## DEEP MEADOW MITIGATION PLAN

Union County, NC  
NCDEQ Contract No. 6887  
DMS ID No. 97131

Re: NCIRT Review and USACE Approval of the Deep Meadow Draft Mitigation Plan;  
SAW-2012-01107; DMS Project #97131

RE: Deep Meadow Mitigation Site  
Union County, NC  
USACE AID#: SAW-2012-01107, NCDMS #: 97131  
FINAL Mitigation Plan – IRT Comment Response

Figure 11 Monitoring Plan Map  
 Deep Meadow Mitigation Site  
 Yadkin River Basin (03040105)

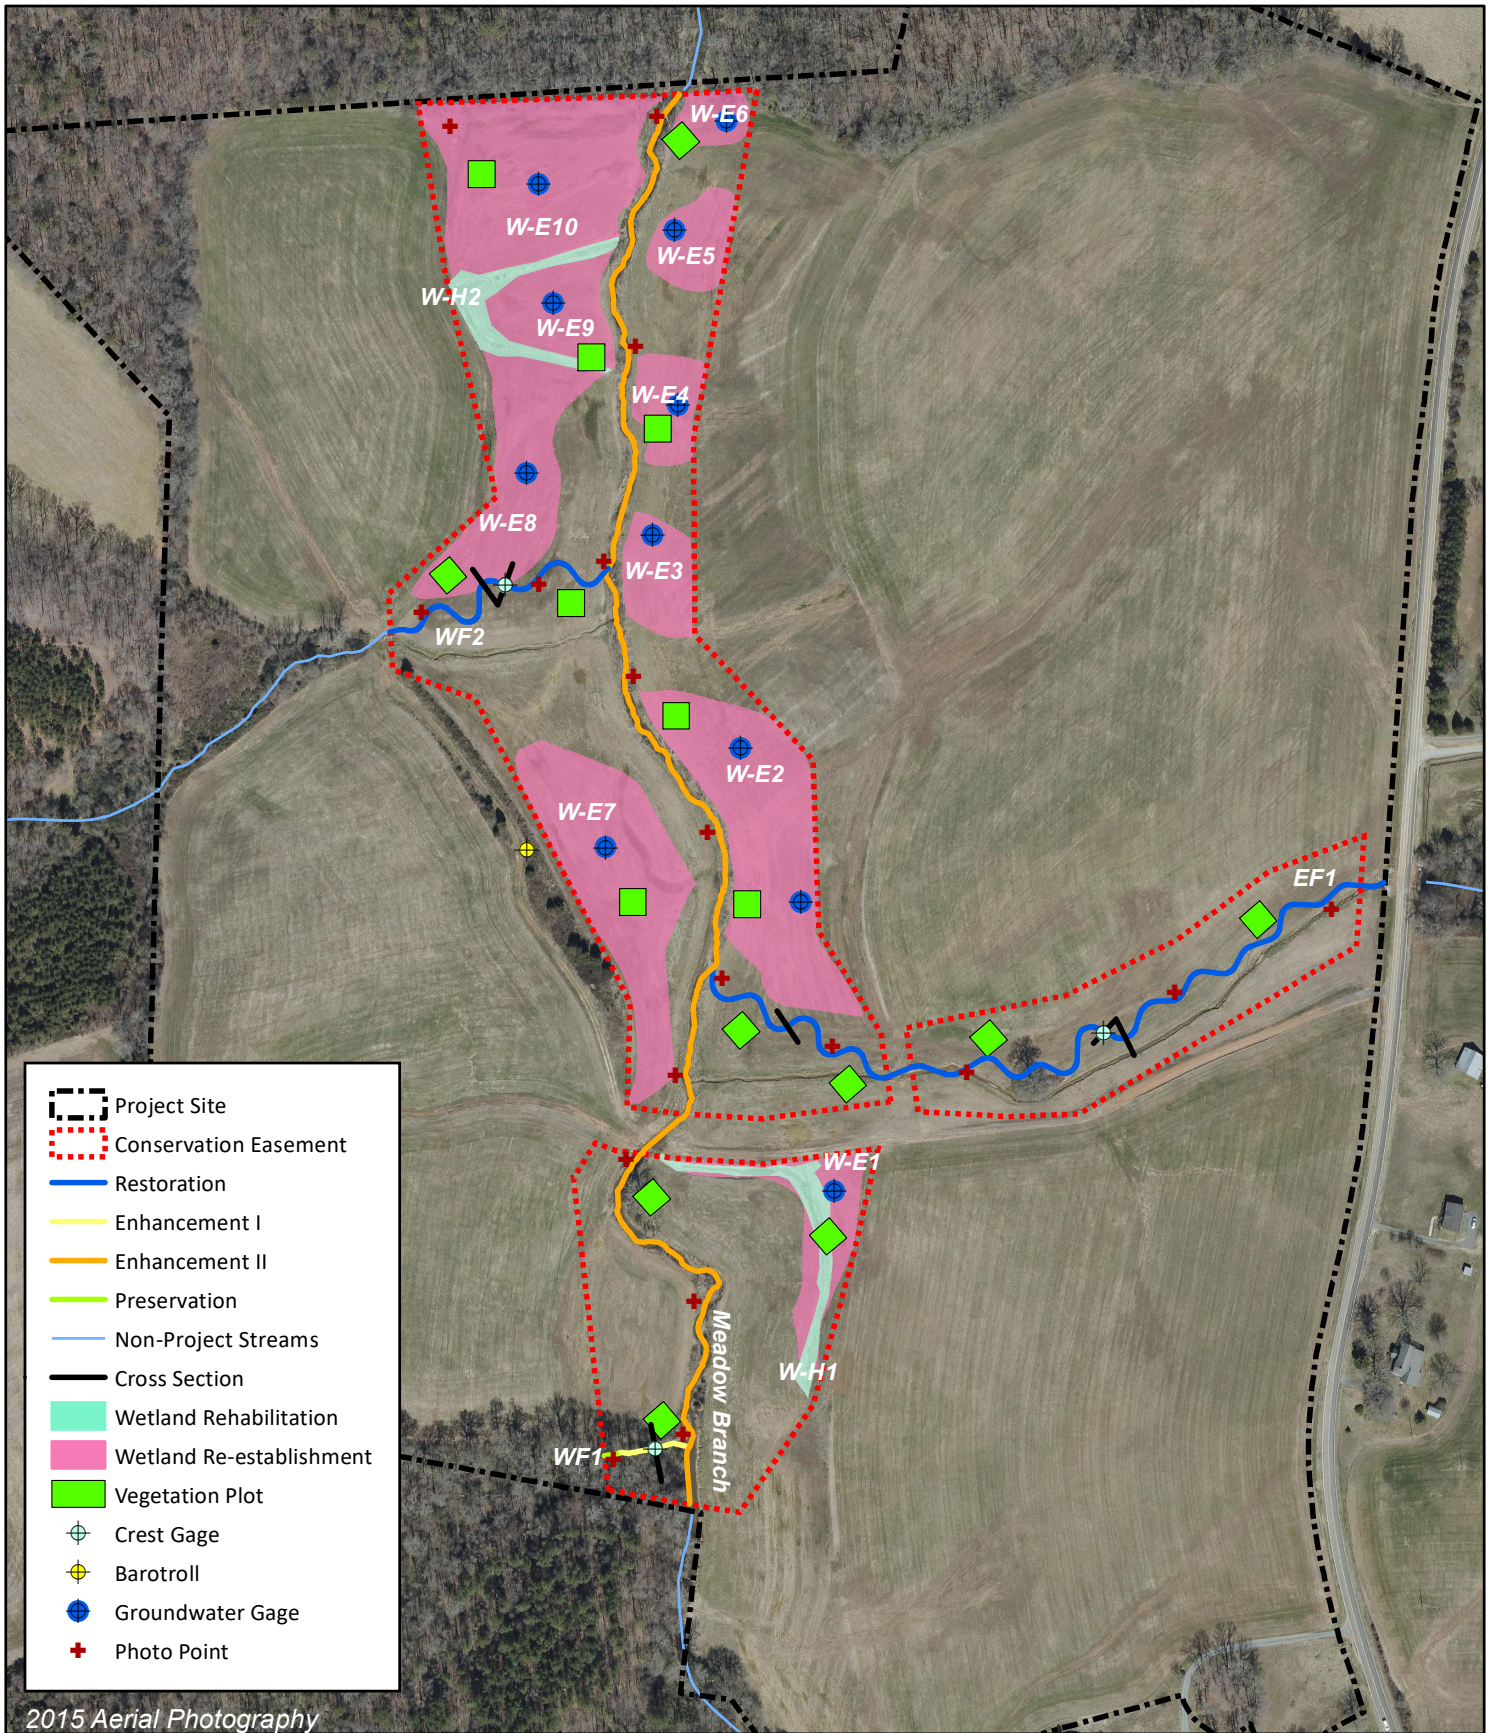
- Figure 11: Recommend additional ground water gages placed in non-wetland areas to verify wetland boundaries within the uplands contained within the conservation easement.

- 18. *Figure 11: Recommend additional ground water gages placed in non-wetland areas to verify wetland boundaries within the uplands contained within the conservation easement.*

Wildlands added proposed groundwater monitoring gages to wetlands W-E6 and W-E4 and added an additional wetland gage to W-E2 as shown in Sheets 3.1 and 3.2 and Figure 11. Gages within W-E6 and W-E4 were placed according to elevation suggestions noted in the comment. One gage within W-E2 was moved above the proposed 486 elevation line. Generally, Wildlands agrees with the groundwater monitoring approach noted above but wants to acknowledge that groundwater monitoring gages are meant to be representative of *overall* wetland mitigation site groundwater conditions and focusing wetland gages to boundaries and/or toe of slopes does not generally fit that criteria. Furthermore, when placing proposed groundwater monitoring gages, Wildlands prefers to overlap pre-construction monitoring gages and, as best as possible, place wells in linear transects to get a better understanding of overall groundwater levels on-site. After the edits above, the preliminary monitoring plan includes 11 groundwater gages for approximately 8.8-acres of restored wetland; which is higher than what has previously been required by the IRT. Wildlands understands that this is due to multiple pocket wetlands on the east side of the Site but does want to acknowledge the extensive groundwater monitoring proposed on the Site.

Additional groundwater monitoring gages were added to the proposed wetland mitigation areas (see comment response #12 above). Wildlands does not intend to gage areas which are not proposed for wetland mitigation crediting.

3.1

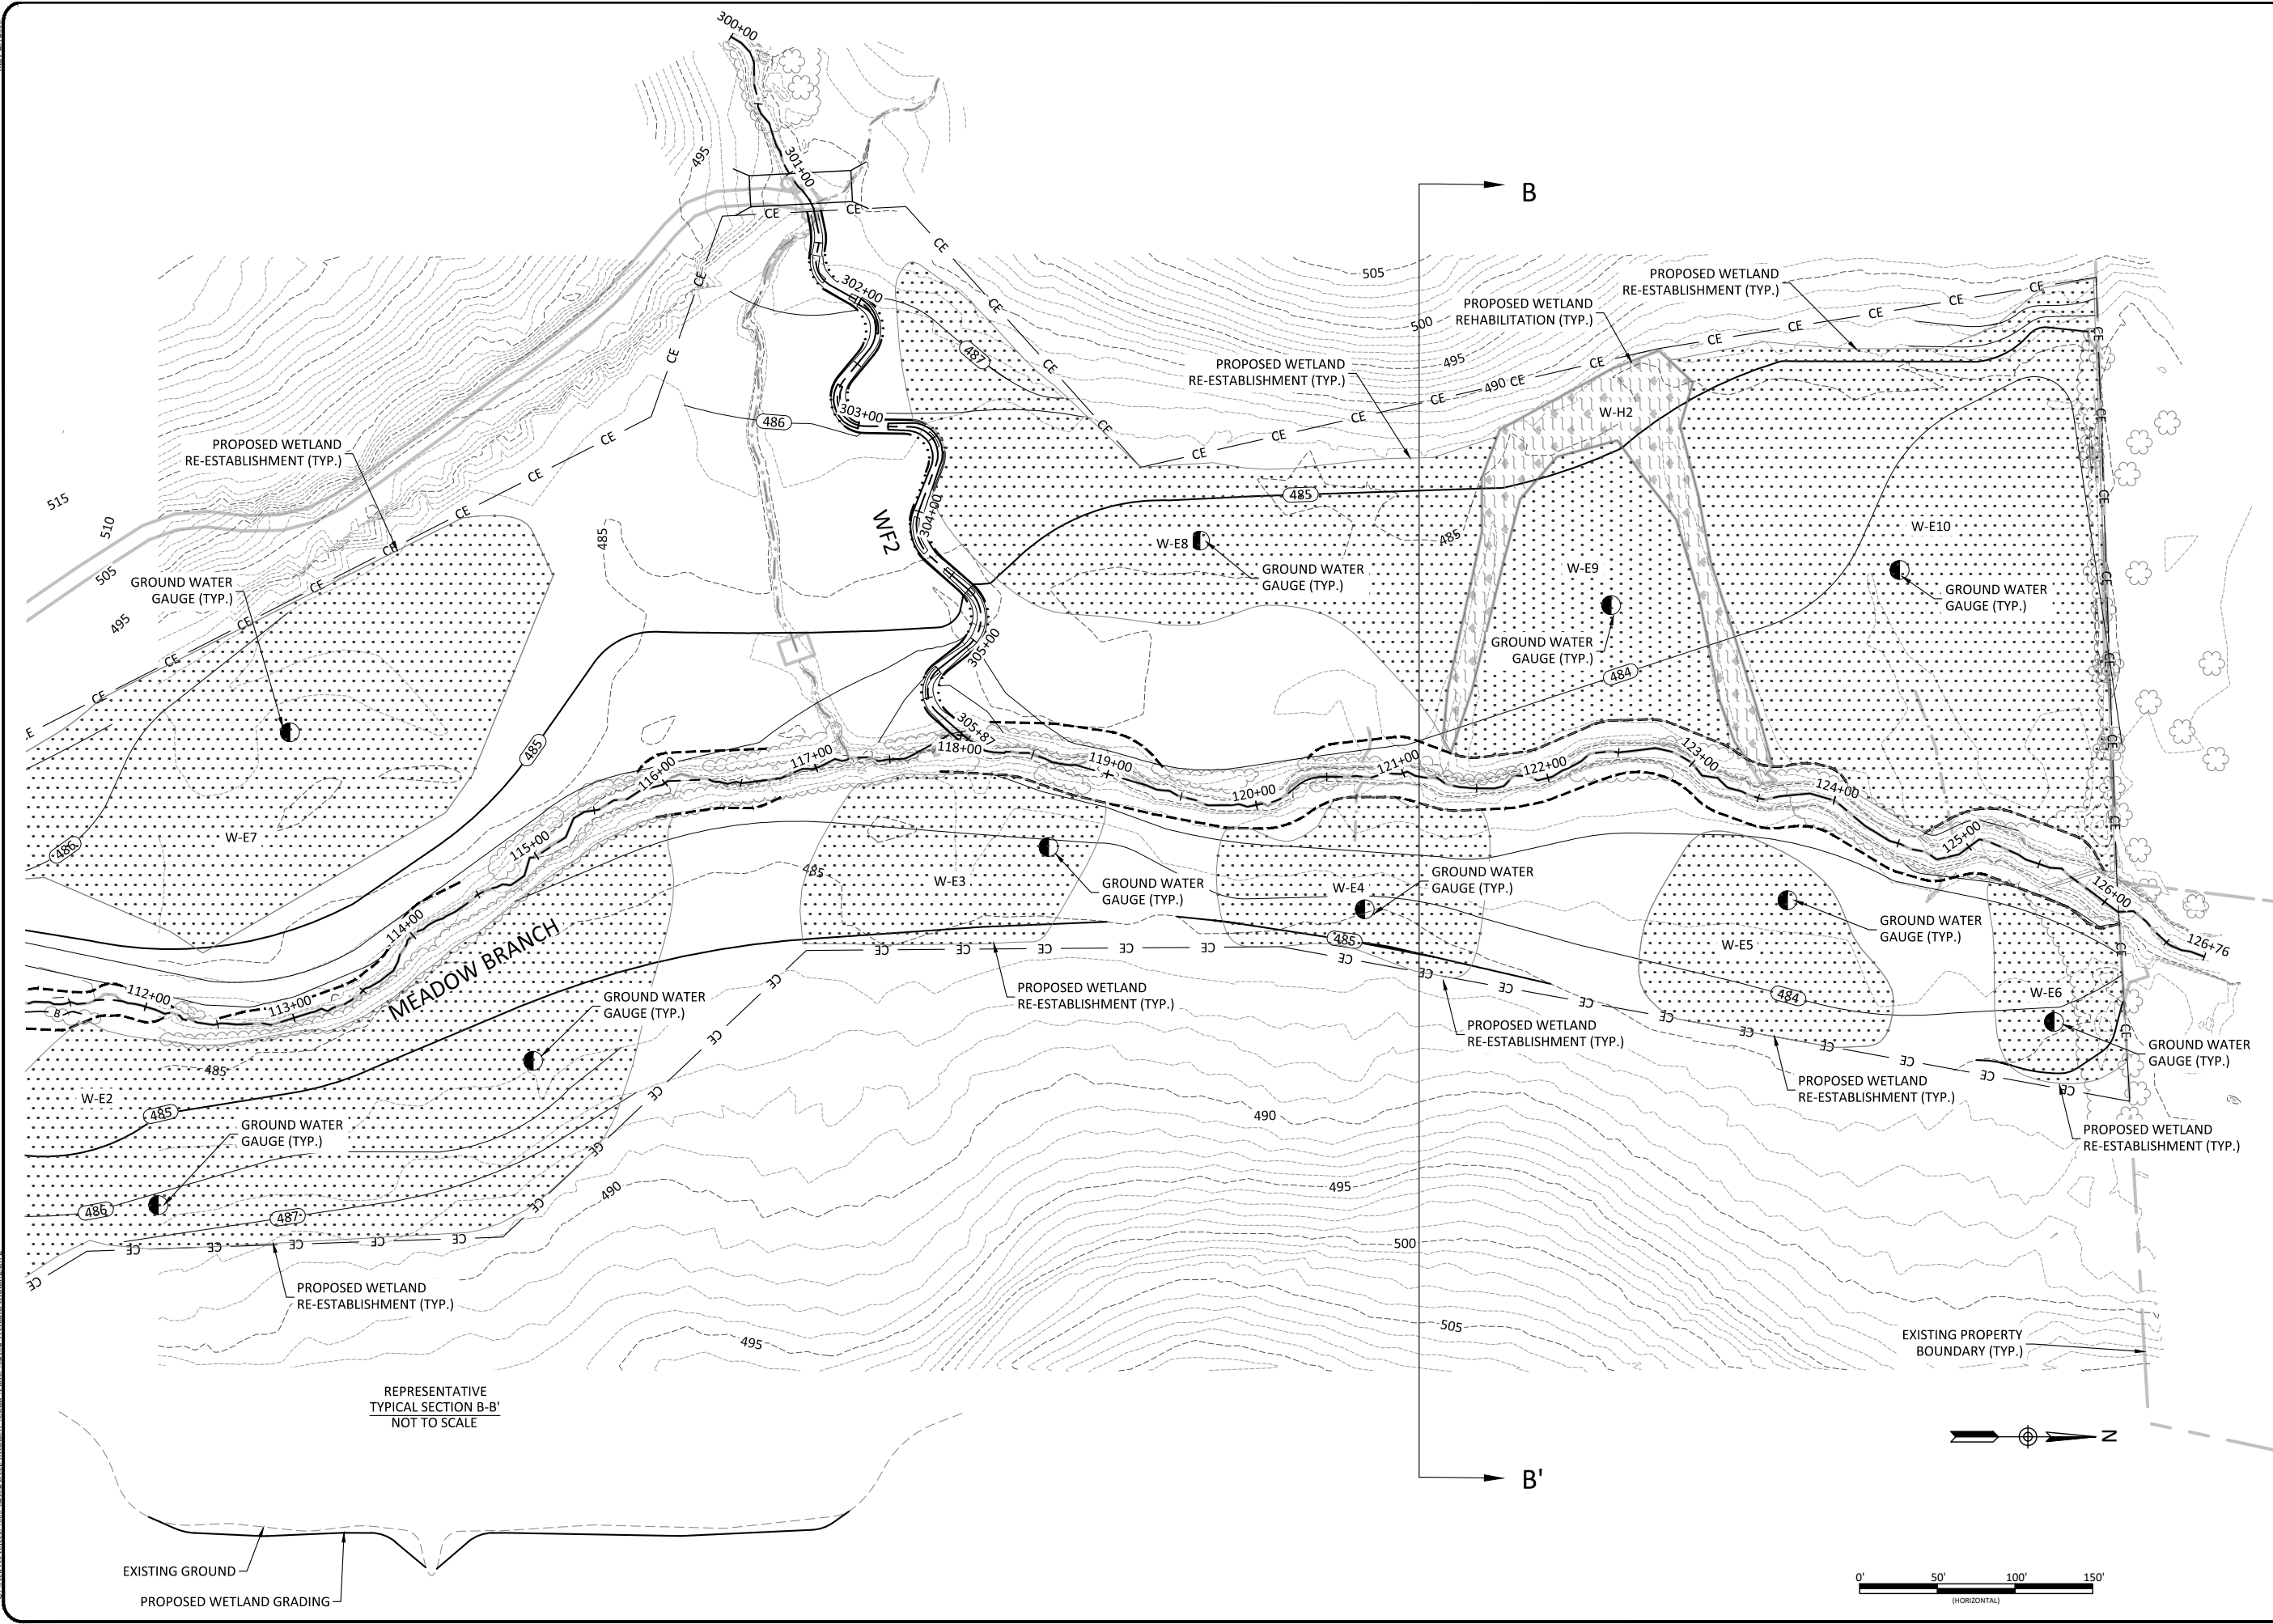
2. DWR will require several additional gauges be placed in the eastern side wetlands. A gauge needs to be placed in W-E6, W-E4, and two gauges placed in W-E2. All of these wetlands were termed "marginal" in the soils report and are more at risk for making the required wetland hydrology standard. Moreover, all additionally placed gauges need to be installed in the upper portions of the wetland polygons. For W-E2, gauges should be placed at and above the 486 elevation line (see wetland grading sheet 3.2). For W-E4, a gauge should be placed between the 484 and 485 elevation lines. For W-E6, a gauge should be placed above the 484 elevation.

*hydrology standard. Moreover, all additionally placed gauges need to be installed in the upper portions of the wetland polygons. For W-E2, gauges should be placed at and above the 486 elevation line (see wetland grading sheet 3.2). For W-E4, a gauge should be placed between the 484 and 485 elevation lines. For W-E6, a gauge should be placed above the 484 elevation.*
